**City of West Linn**  
**PRE-APPLICATION CONFERENCE**  
**SUMMARY NOTES**

**February 4, 2010**

SUBJECT: Willamette and Tualatin River Protection at 2130 Windham Oaks Court  
ATTENDEES: Applicant: Tacia Miller, Steve Mills (GeoDesign) Jeffrey Simpson (Simp.L)  
Staff: Peter Spir (Associate Planner) Khoi Le, City Engineer

## Council's recommendation on habitat protection

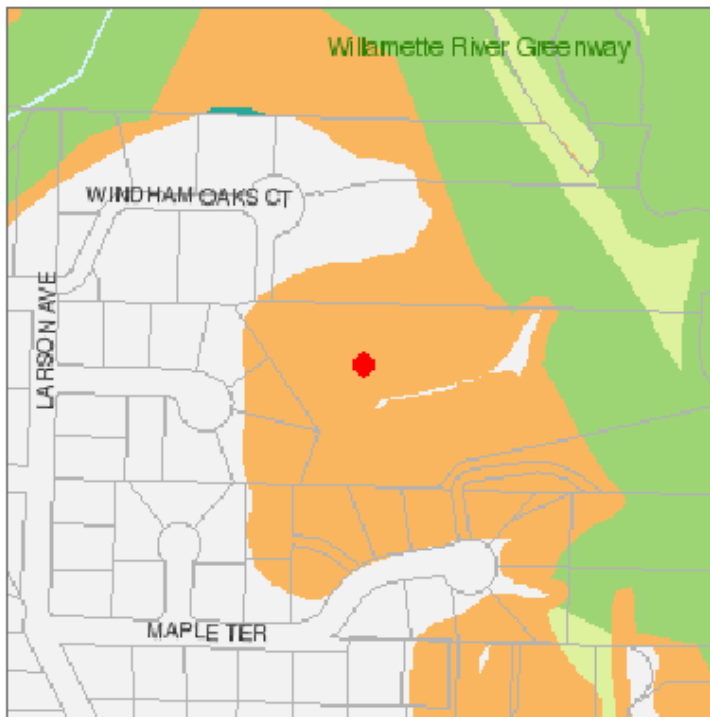
Slope failure just beyond this point

Distance from pool to slope failure is about 35-50 feet
